**PROPOSED ROAD UPGRADE WORKS
AT BELVIEW, CO. KILKENNY**

Road Safety Audit Stage 1

Project Title	Proposed Road Upgrade Works at Belview, Co. Kilkenny
Project No.	25045-02
Document Title	Road Safety Audit Stage 1
Document No.	25045-02-001

2.7 **Problem:** Inadequate Lighting

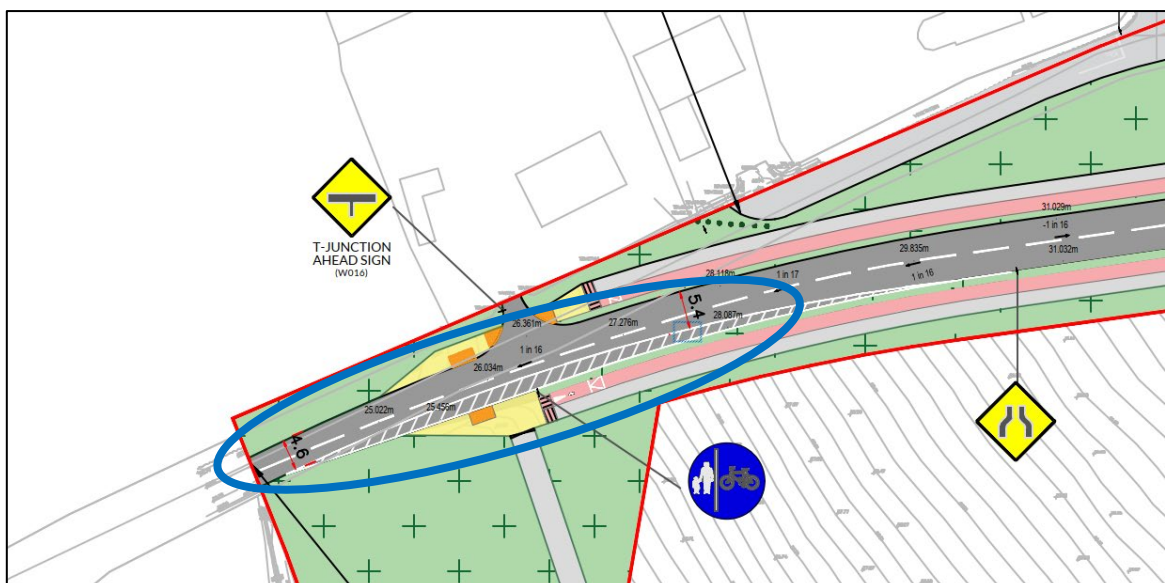
Location: Pedestrian Crossings

The proposed scheme includes a detailed lighting design. However, it is unclear whether all pedestrian crossings are adequately illuminated. The proposed lighting appears to leave dark spots near some crossings relative to adjacent areas. This may make the crossing locations less conspicuous leading to motorists not noticing pedestrians at these locations. This increases the likelihood of collisions.

Recommendation: Ensure sufficient lighting is provided at all pedestrian crossing locations.

2.8 **Problem:** Inadequate Lane Width

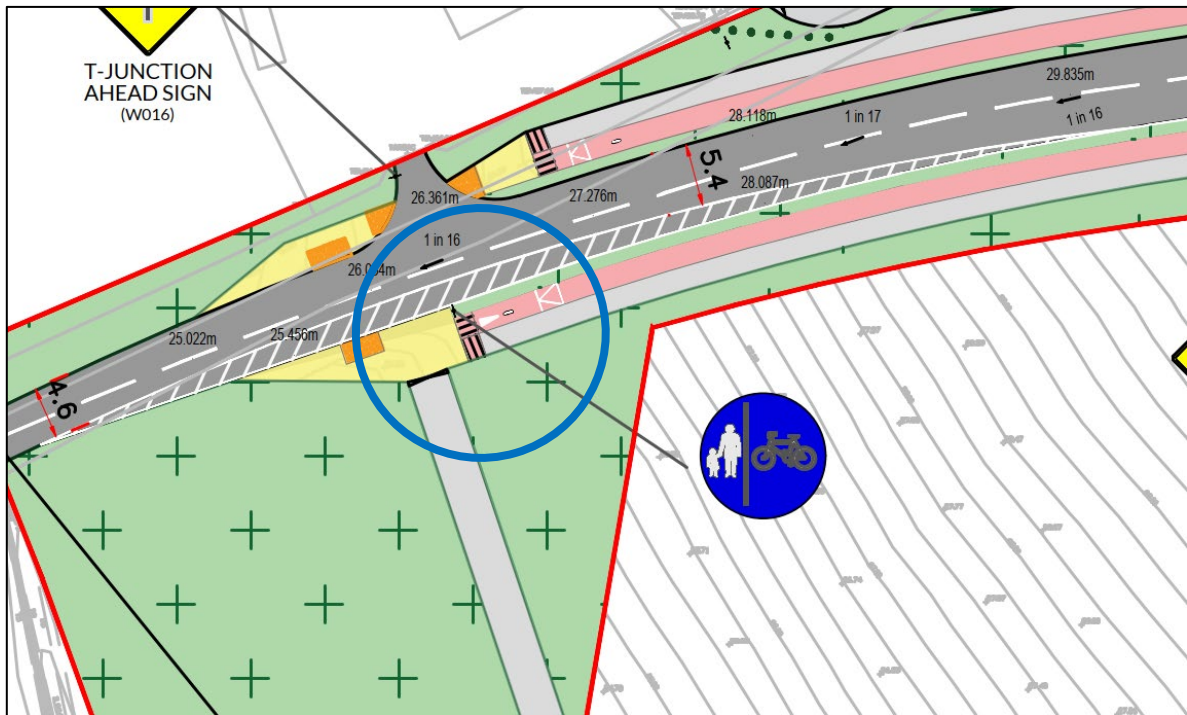
Location: Near Western tie in

The lane width of the westbound lane appears to be narrow compared with the eastbound lane. This reduced width may not provide sufficient clearance for vehicles when encountering heavy vehicles in the opposing lane. As a result, there is an increased risk of side-swipe collisions.

Recommendation: The layout should be amended so that the width and curvature of each lane is adequate for vehicles to pass safely.

2.11 Problem: Insufficient turning width

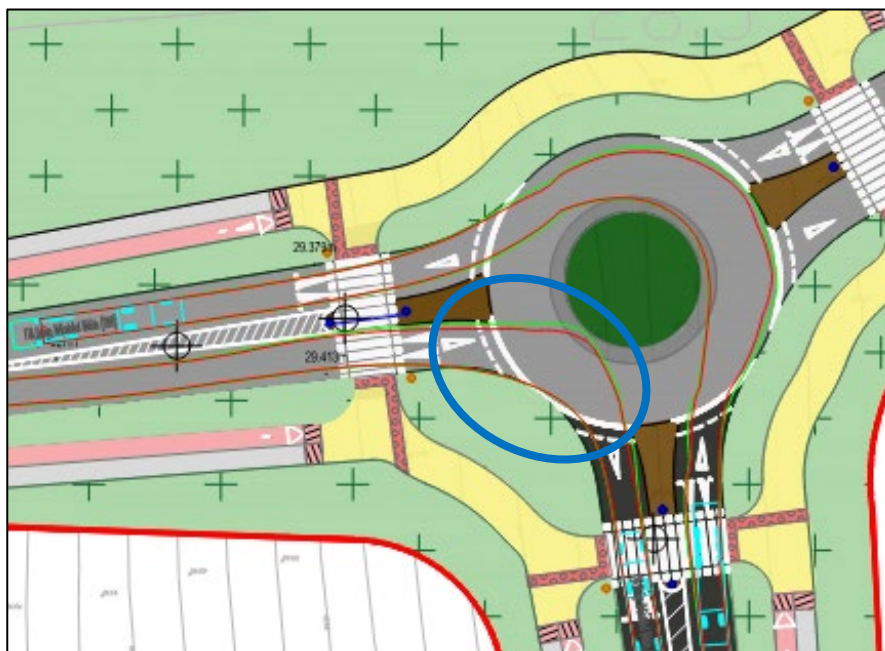
Location: Western arm of western roundabout

The swept path analysis indicates that there is insufficient space to accommodate turning within the road surface by the design vehicle. This may lead to unanticipated movements and associated collisions.

Recommendation: Adequate space should be provided to accommodate anticipated vehicles.

2. 12 Problem: Inadequate visibility

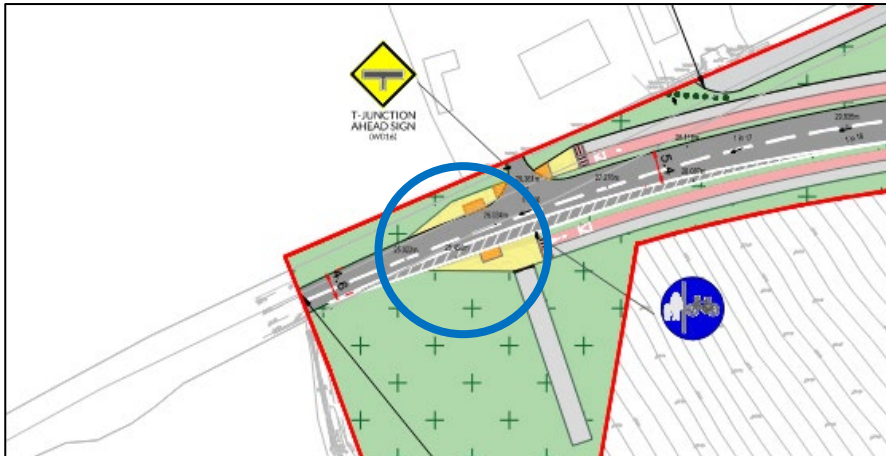
Location: Uncontrolled crossing at western tie in

It is unclear if adequate visibility is available between the proposed uncontrolled crossing and traffic approaching from the west. Inadequate visibility may lead to collisions at the crossing.

Recommendation: Adequate visibility should be provided to and from the crossing.

2. 13 Problem: Discontinuous facilities

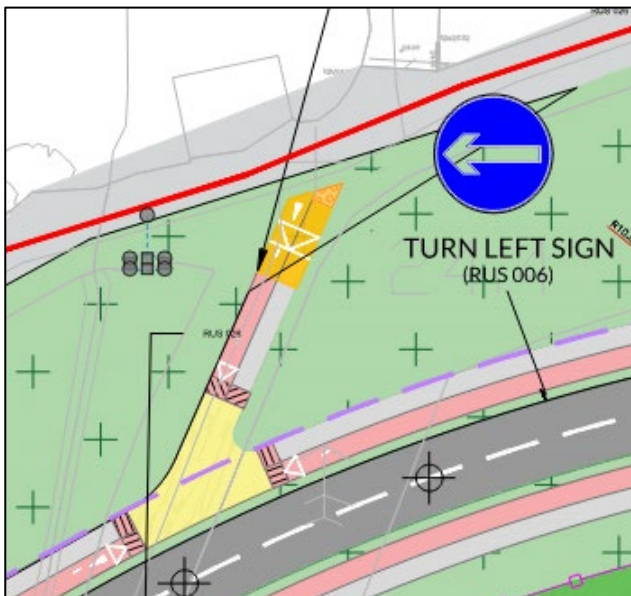
Location: Active travel link at the centre of the scheme, northern side

A proposed active travel link appears to terminate into landscaping and without appropriate transition to the existing road. It is unclear also if appropriate sight lines are available at this location. This may lead to collisions between motorists on the existing road and vulnerable road users joining the existing road.

Recommendation: Appropriate connection should be provided.

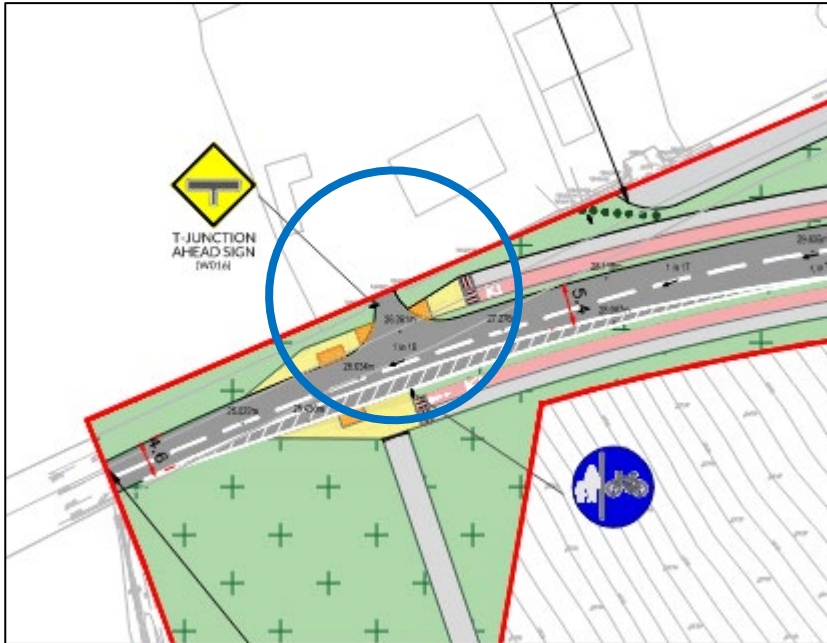
2. 14 Observation: A junction-type treatment with relatively large corner radii and uncontrolled crossing facilities appears to be applied to a private access. This, along with the T-junction ahead warning sign, appear unnecessary and may be confusing for motorists.
